City of Willow Park Planning & Zoning Commission Regular Meeting 516 Ranch House Rd, Willow Park, TX 76087 Tuesday, July 16, 2019 6:00 pm Agenda

P&Z AGENDA ITEM BRIEFING SHEET

Consider and Act on a Site Plan for a church on Lot 1, Block B, Fawcett Addition, located at 700 Willow Crossing Drive East.

City of Willow Park Development Services Universal Application

A-1

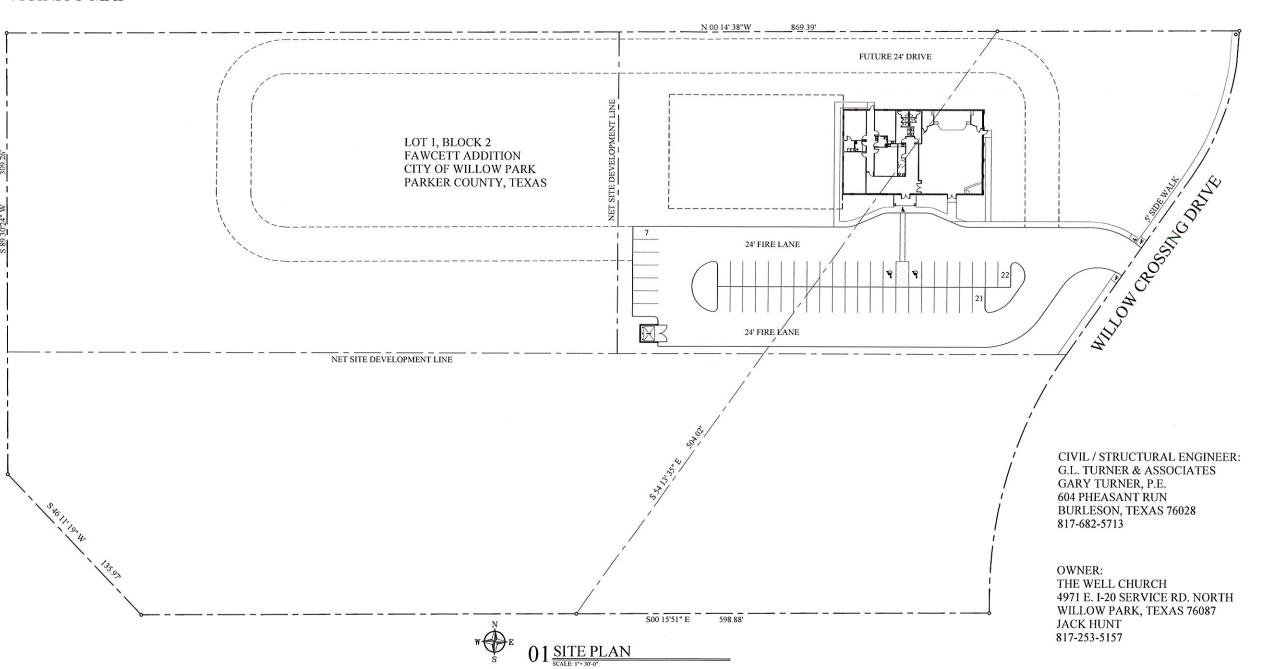
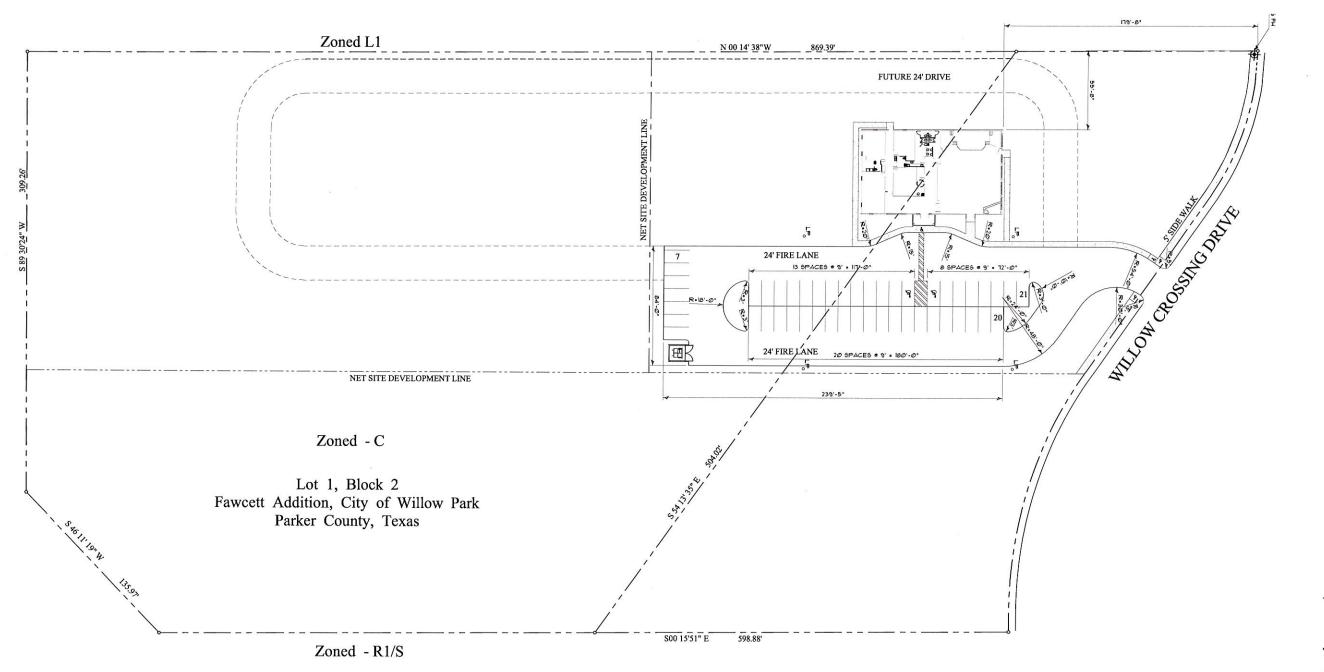
- 1. Building setback lines be shown on the site plan.
- 2. Zoning Classification of property to the east and west corrected.
- 3. Existing easements on entire property shown on site plan.
- 4. Cement siding and residential windows replaced within 5 years of Phase 1 completion or addition to the building.
- 5. Add dumpster location and screening.
